GA2 hybrid planning application

Transport comments on 25/03080/HYA

Figure 1: Extract from Mendip Way Means of Access Plan (19244-ASHB-5-SK005 Rev C)

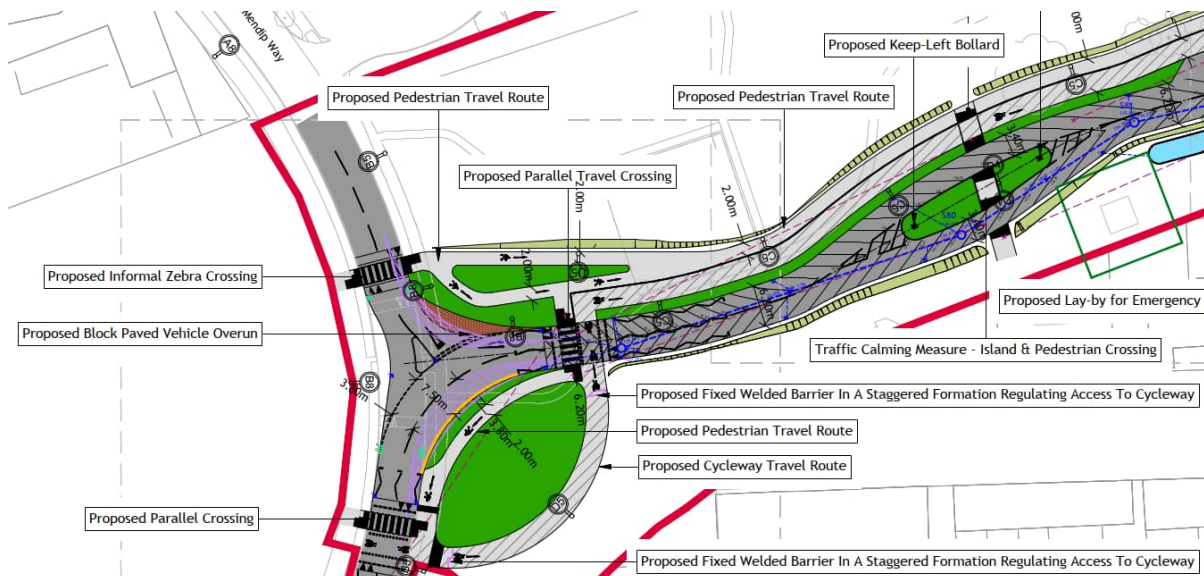
- 2.3 The design of the cycle track north of the crossing just east of Mendip Way does not comply with LTN1/20 or PMPDG standards (see Part 3 Chapter 4 p98), which specify a minimum corner radius for bends of 4m. The track should be curved and the adjacent footway adjusted accordingly.

- 2.4 The crossing of Mendip Way to the north is labelled as an “informal zebra crossing”. Such a design is not currently permitted in TSRGD. The crossing should either be shown as a compliant zebra crossing (with zigzags and Belisha Beacons) or as an informal crossing (if that is acceptable to the HCC DMI team). Note that, to achieve the recommendation set out in §2.7, this would need to be either a parallel or informal crossing.

- 2.5 The geometry of the access junction is designed to prevent vehicles turning right from the access road into Mendip Way to the north. (As indicated in the tracking diagrams, it is intended that all vehicles would travel via the Great Ashby Way roundabout instead.) However, the relevant “no right turn” signage is not shown on the plan.

- 2.6 It is unclear why the footway widens out north of the southern Mendip Way crossing as pedestrians should not have to wait here. Not tapering the strip of verge would create a more successful and manageable green space (see Figure 2)

Figure 4: Extracts from Mendip Way Means of Access Plan (19244-ASHB-5-SK005 Rev C) and Planting Plan (DL50-1)

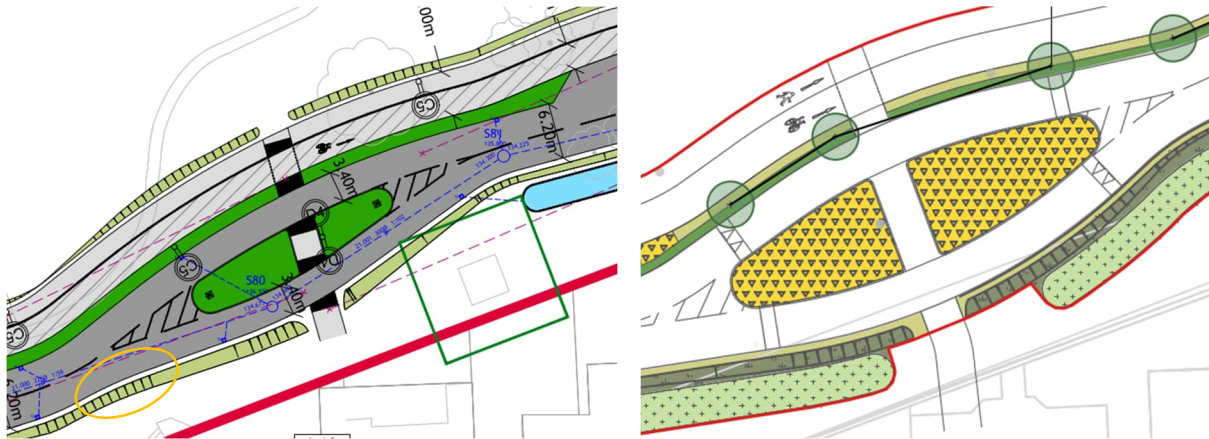
- 2.10 The Planting Plan shows ramps to raised crossings at the islands. These are not shown on the Means of Access infrastructure plan. One or other of these plans should be updated for consistency.

- 2.12 The kink in the access road eastbound before the island may not be sufficiently sharp to achieve the desired 20mph maximum speed. This may potentially be improved by straightening the reverse curve on the westbound lane – ringed in orange in Figure 4. If proposed, the addition of ramps to raised tables (see §2.10) would also have a speed-limiting effect.
